TO: John Sponseller
FROM: Carson Byerhof, Planner I
DATE: July 28, 2022
SUBJECT: SP22-041 – Dunkin Donuts
Review Comments 01

**SITE PLAN FOR
DUNKIN' DONUTS
DOUGLAS 234, FILING NO. 6,
AMENDMENT 1, LOT 4**

SITE PHOTOMETRIC PLAN

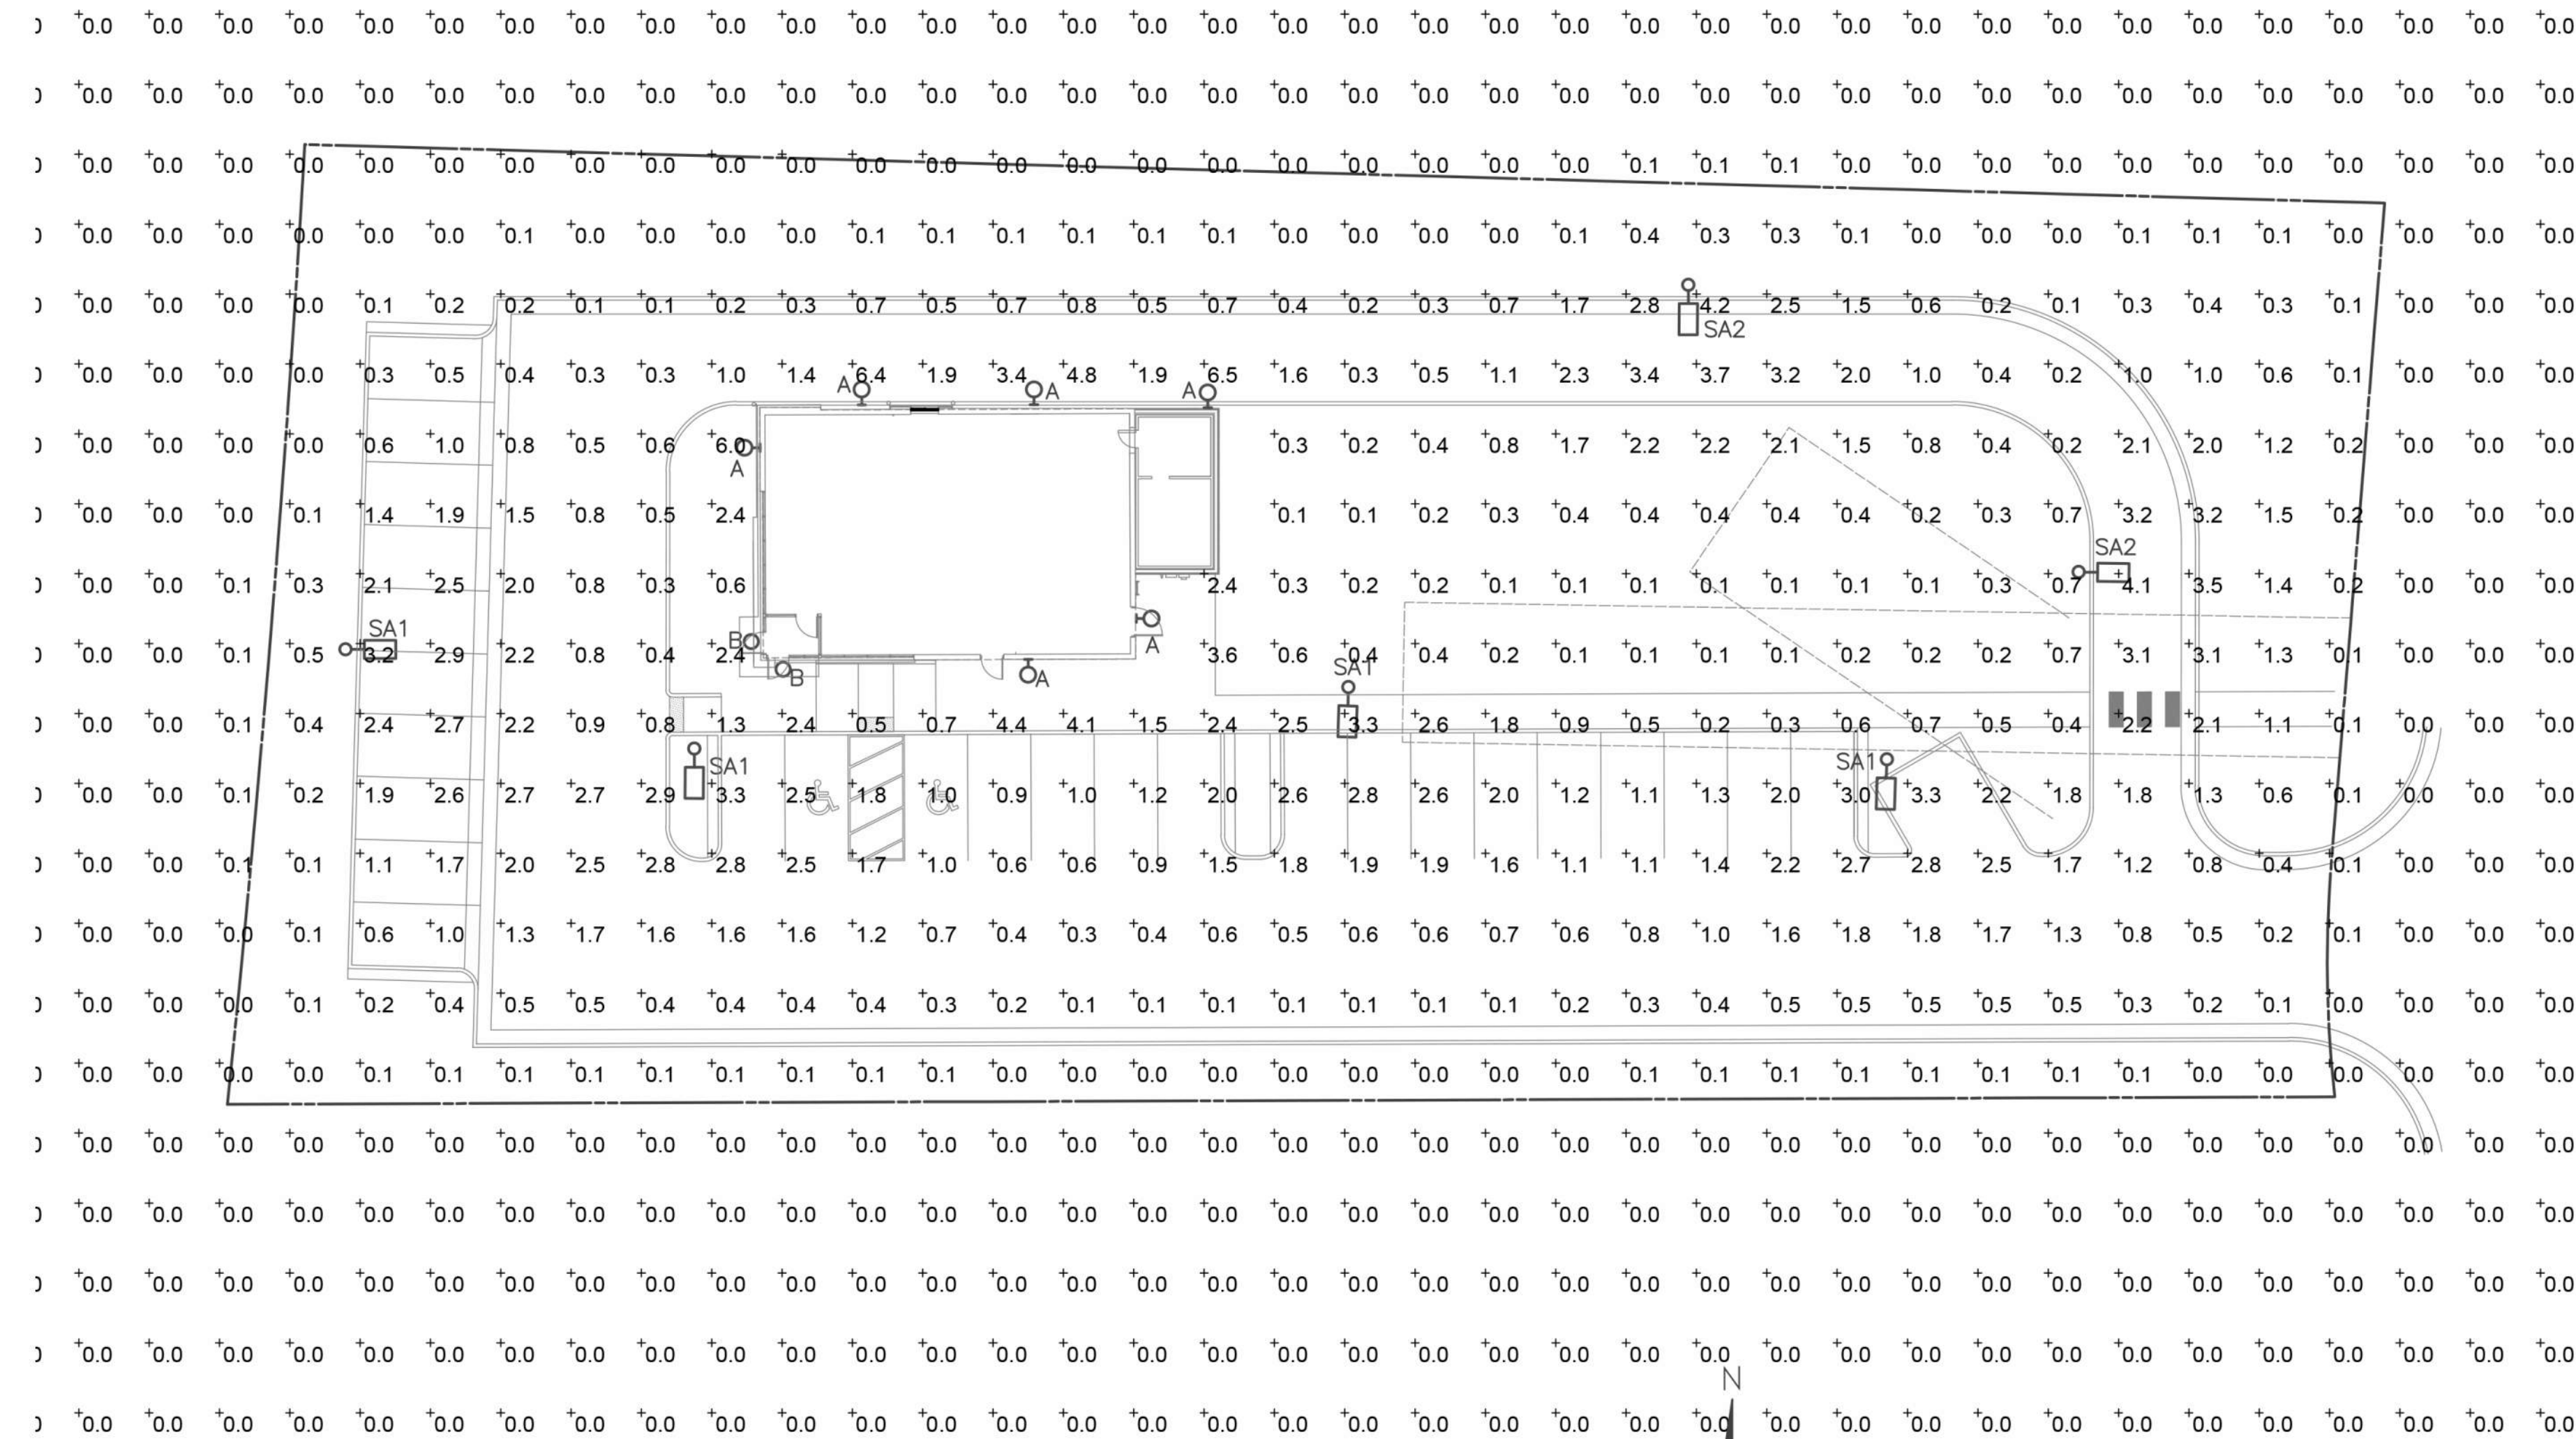
Include ratios for next review. Calculations should use 0.1 as minimum. Adhere to commercial lighting uniformity standards §13.10.140 - (e). See example called out
